NINE MILE POINT NUCLEAR STATION, UNIT NO. 1

AMENDMENT TO FACILITY OPERATING LICENSE

Amendment No. 58
License No. DPR-63

SUPPORTING AMENDMENT NO. 58 TO FACILITY OPERATING LICENSE NO. DPR-63

FIGURE 3.2.2.a

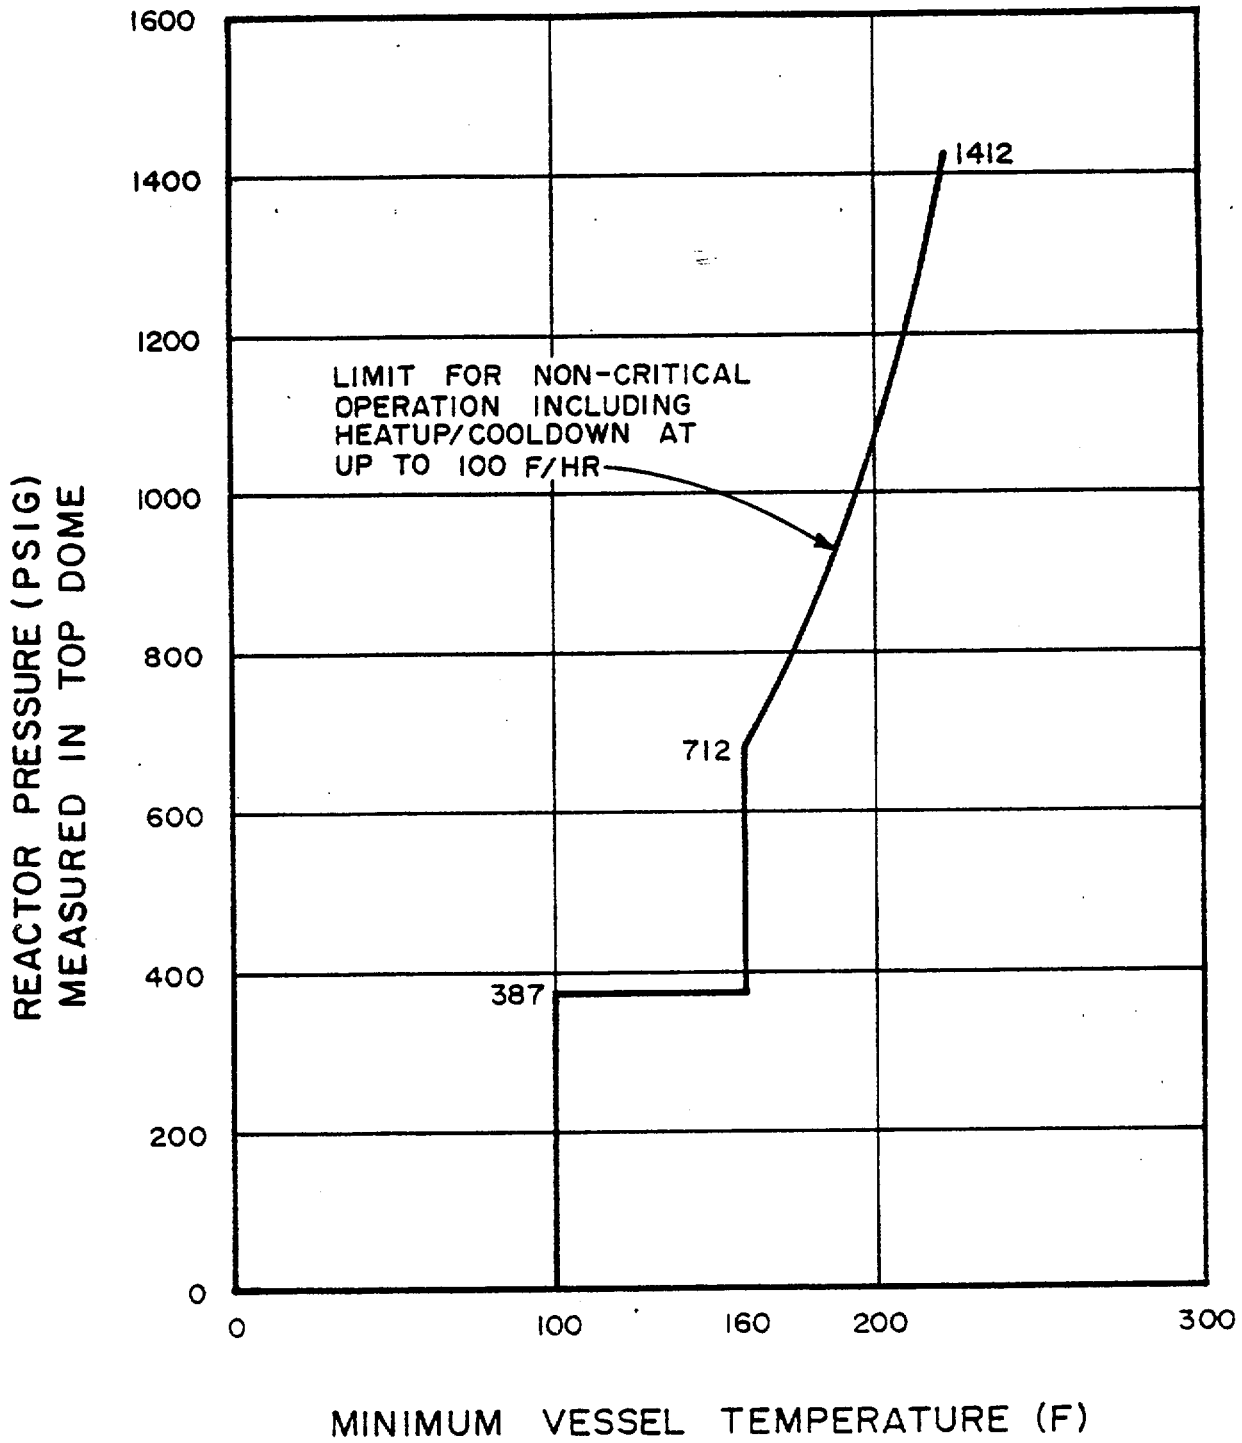
a. During reactor vessel heat-up and cooldown when the reactor is not critical the reactor vessel temperature and pressure shall satisfy the requirements of Figure 3.2.2.a.

Figures 3.2.2.a, 3.2.2.b, 3.2.2.c and 3.2.2.d have incorporated a temperature shift due to the calculated integrated neutron flux. The integrated neutron flux at the vessel wall is calculated from core physics data and has been measured using flux monitors installed inside the vessel. The curves are applicable for up to ten effective full power years of operation.

FIGURE 3.2.2.b

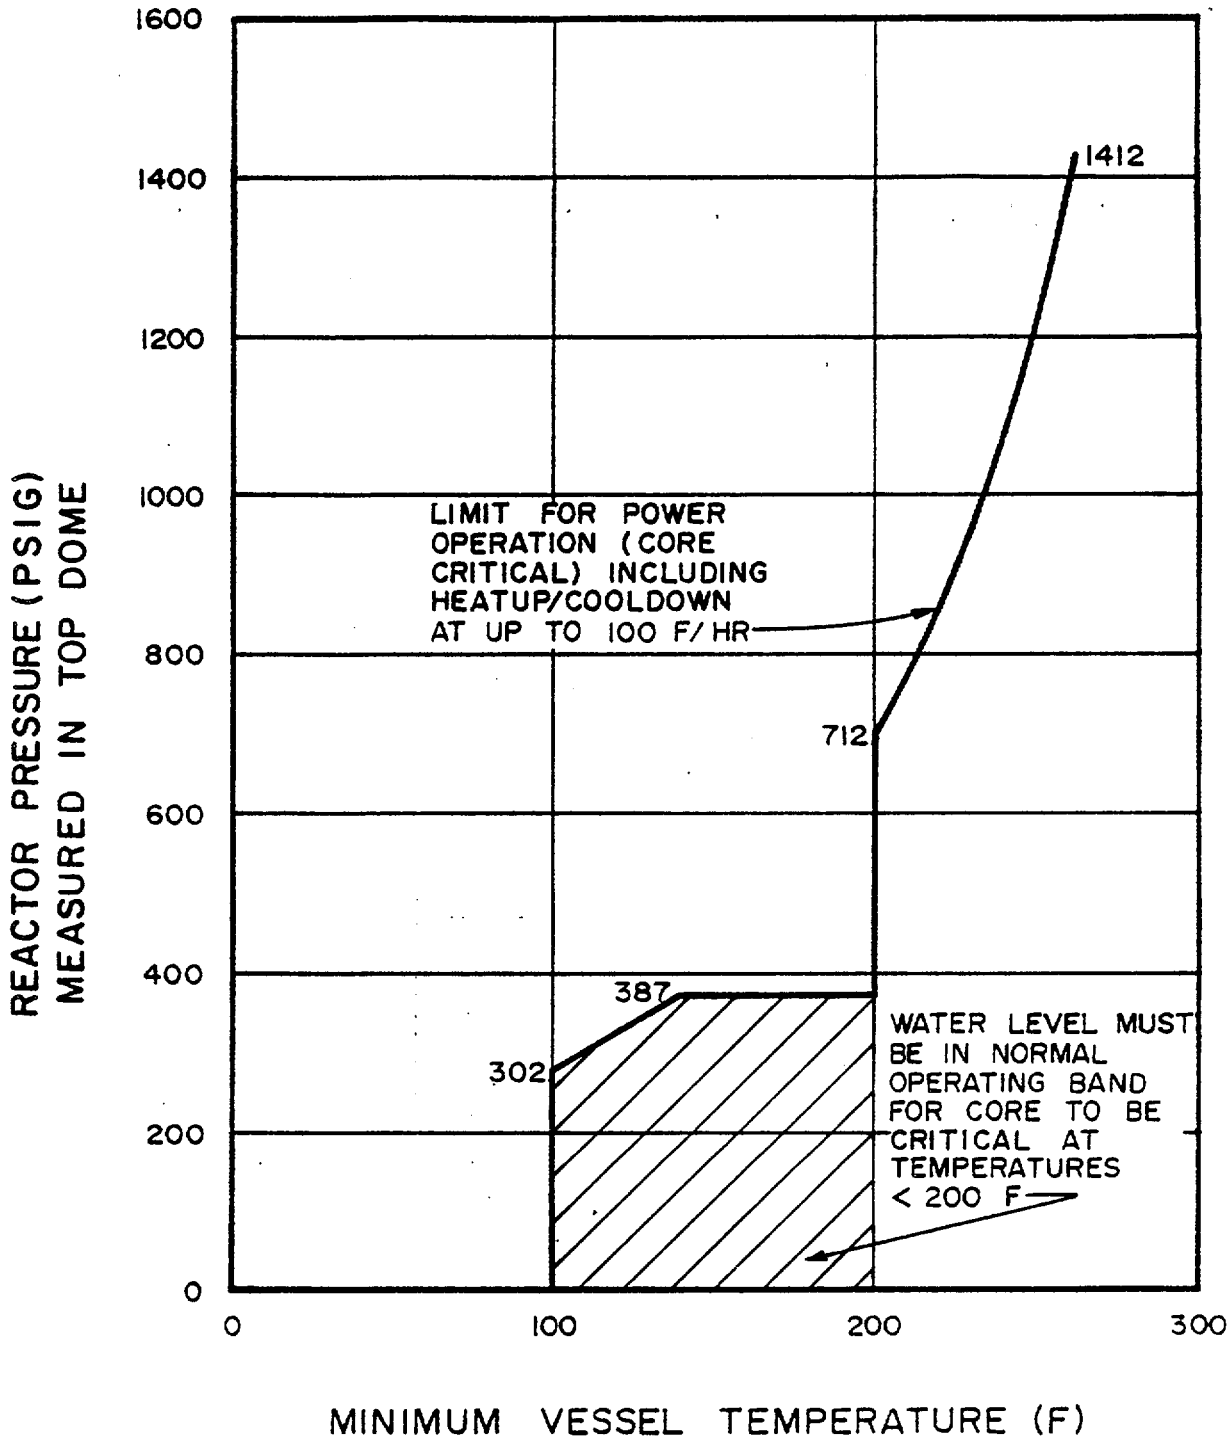
b. During reactor vessel heat-up and cooldown when the reactor is critical the reactor vessel temperature and pressure shall satisfy the requirements of Figure 3.2.2.b, except when performing low power physics testing with the vessel head removed at power levels not to exceed 5 mw(t).
